TSG-RAN Meeting #11 ***RP-010093***
Palm Springs, CA, USA, 13 - 16 March 2001

Title: **Agreed CRs (Release '99) to TS 25.142**

⌘ **25.142** **CR** **47** ⌘ rev **-** ⌘ Current version: **3.4.0** ⌘

Title:	⌘	Correction of blocking test. Alignment with CR to 25.105.
Source:	⌘	RAN WG4
Work item code:	⌘	***Date:*** ⌘ 19.02.01
Category:	⌘ **F**	***Release:*** ⌘ R99

Figure 5.14~~2~~.5.1: Receiver test setup

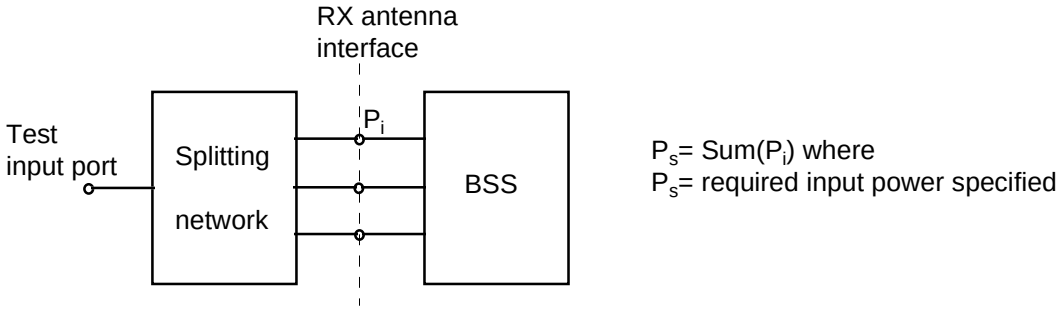
An example of a suitable test configuration is shown in figure 5.14~~2~~.5.1.

Figure 5.1~~4~~2.5.2: Transmitter test setup

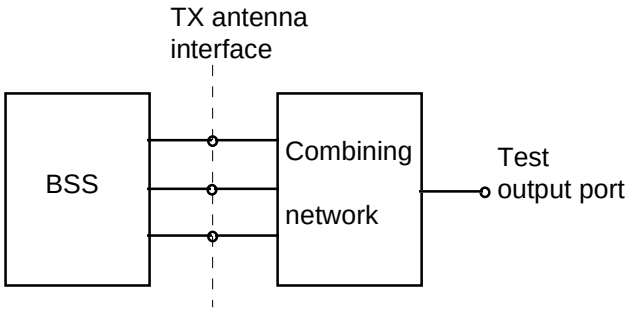
An example of a suitable test configuration is shown in figure 5.14~~2~~.5.2.

Figure 6.5.2.2.1: Transmit ON/OFF template

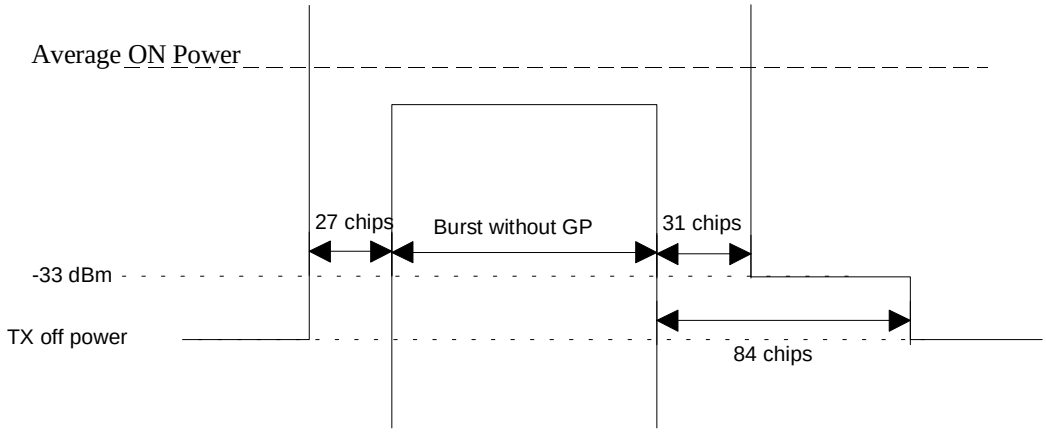
Each value of the power measured according to subclause 6.5.2.4.2 shall be below – 32,3 dBm in the period from 32 chips to 84 chips after the burst and – 77 dBm in the period where the Tx OFF power specification is applicable~~the limits defined in figure 6.5.2.2.1 of subclause 6.5.2.2~~.
